**PLANNED UNIT DEVELOPMENT
& SUBDIVISION STAFF REPORT****Date: July 7, 2011**

| <u>DEVELOPMENT NAME</u> | Oakleigh Place Subdivision, Re-subdivision of Lots 8 & 9 |
| <u>CONTEMPLATED USE</u> | Planned Unit Development and Subdivision approval to amend a previously approved Planned Unit Development and Subdivision to change the front lot line between lots 8 and 9 to allow a driveway for lot 8. |

SITE PLAN

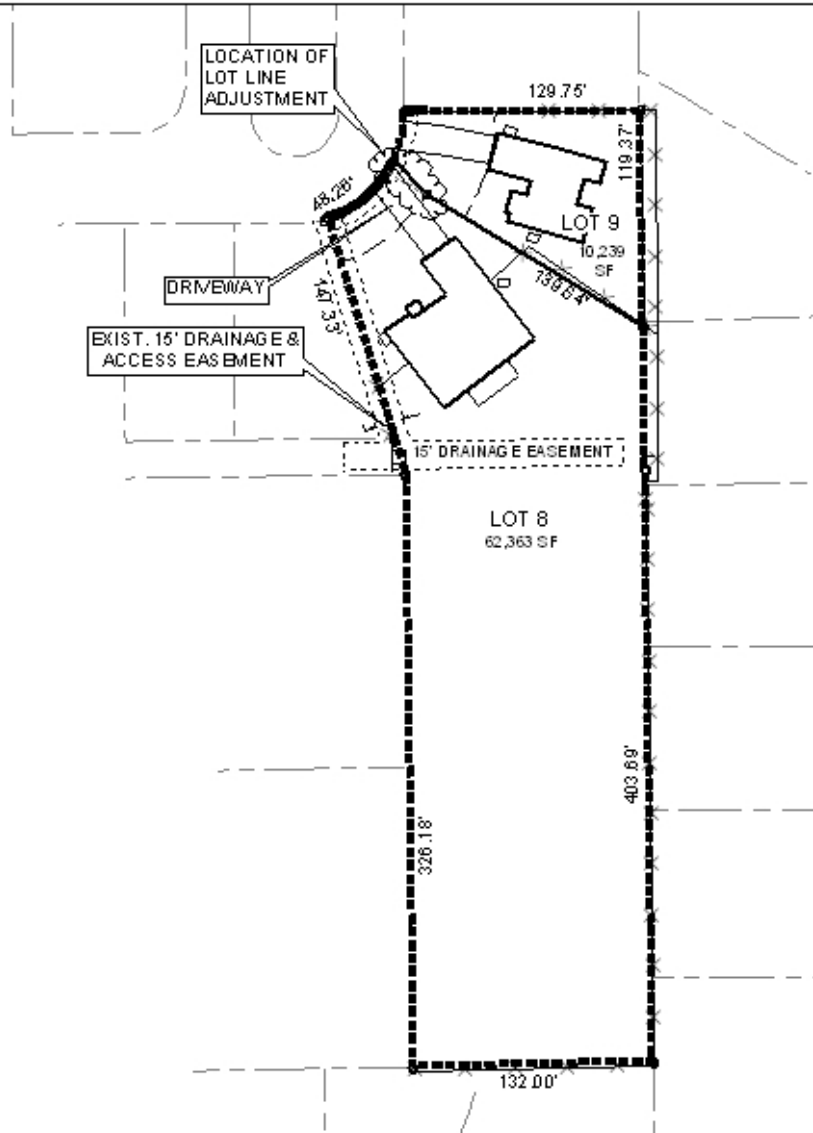
Each lot appears to meet minimum size requirements, and each are labeled with their size in square feet on the preliminary plat. Both lots also have the minimum front setback lines depicted and labeled. It should be noted that some of the front setbacks exceed the 25-foot minimum, as they are placed where the lot is 60-feet wide. These items should be retained for the final plat and site plan, if approved.

Proposed Lot 8 exceeds the width to depth ratio of Section V.D.3. of the Subdivision Regulations, however, the shape of the property makes it difficult to provide adequate street frontage. A waiver of this section may be appropriate.

Lot 8 additionally contains a drainage easement along a portion of the West property line, and partially across the site. A note should be placed on the final plat stating that no structures shall be built within the drainage easement.

- 1) depiction and labeling of the minimum building setback line to be at least 25-feet from all street frontages for all lots, or where the lot is a minimum of 60 feet in width for lots less than 60-feet wide at the street, as shown;

- 3) placement of a note on the site plan and plat stating that no structures are allowed within the drainage easement on Lot 8;
- 4) labeling of all common areas, if any, and placement of a note on the site plan and plat stating that maintenance of common areas is the responsibility of the property owners;

- 5) placement of a note on the site plan and plat that each lot is limited to one curb-cut, with the size, design and location to be approved by Traffic Engineering and in compliance with AASHTO standards, as shown;
